**OXFORDSHIRE COUNTY COUNCIL'S RESPONSE TO CONSULTATION ON THE
FOLLOWING DEVELOPMENT PROPOSAL**

Application no: 13/01019/REM

Proposal: Landscaping scheme and play areas for greenway

Location: Land north east of Whitelands Farm and adj. to KM3, Whitelands Way,
Chesterton

This arrangement is shown on the WSP drawing 1903/GW/GA01) Rev A, and in-principle within the approved Kingsmere Phase 1 Design Code:

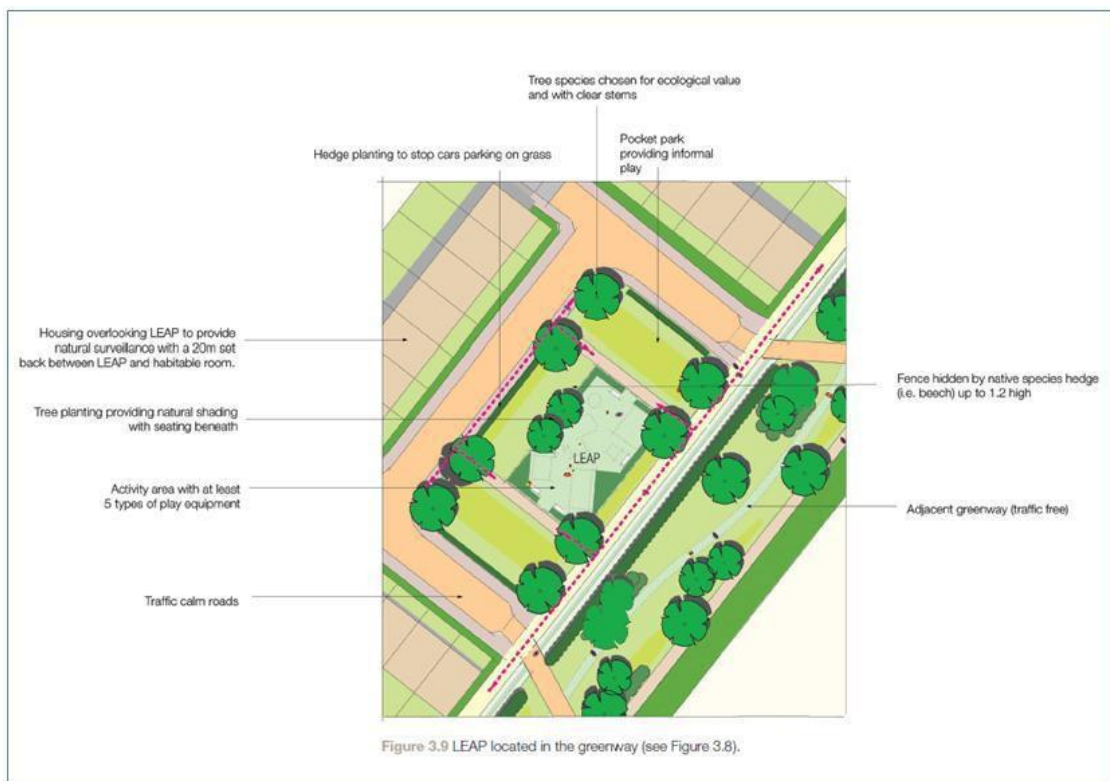
Within this scheme there are to be two fixed vehicular crossings through the Greenway. These crossings will be located either side of the proposed LEAP, one being a Secondary Street, the other being a Side Street.

There is some concern that the link between the Secondary and Side Streets across the Greenway may have poor visibility with all the proposed planting and the fact that the route is more diagonal than straight. It is expected that vehicle use along this route will be light, however there may be times when vehicles will meet and may have pass each other by overrunning onto the Greenway.

To deter damage to the Greenway it is recommend that grasscrete (or a similar material) is used along both sides of the Greenway to strengthen (reinforce) and protect the Greenway from overrunning damage.

The provision of bollards around the entrance features onto and within the Greenway is a design issue that does need consideration by both the Local Planning Authority (LPA) and the Local Highway Authority. If bollards are considered appropriate by the LPA these should be removable/collapsible for future maintenance purposes. The type of bollard that would be considered in this location is knee high ones (with reflective bands). Such a bollard type could be erected in specific locations to ensure vehicles keep to their specific route and to deter cars etc parking on the Greenway.
